FLASH MIL ILLUMINATION DTC P1004 - SHORT RUNNER VALVE PERFORMANCE

TECHNICAL SERVICE BULLETIN

Reference Number(s): 18-003-07 REV. A, Date of Issue: March 07, 2007

CHRYSLER: 2007 (CS) Pacifica; 2007 (JS) Sebring; 2007 (LE) 300/Touring (International Markets); 2007 (LX) 300/Magnum/Charger

Fig. 1: Identifying Authorized Modification Label
Courtesy of CHRYSLER CORP.

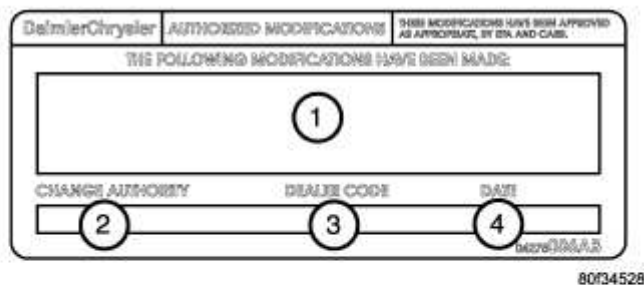
6. Type the necessary information on the "Authorized Modification Label" p/n 04275086AB and attach near the VECI label (**Fig. 1**).

- 1 - POWERTRAIN CONTROL MODULE P/N (INSERT P/N) USED
- 2 - CHANGE AUTHORITY: TSB XX-XXX-XX
- 3 - DEALER CODE: XXXXX
- 4 - DATE: XX-XX-XX
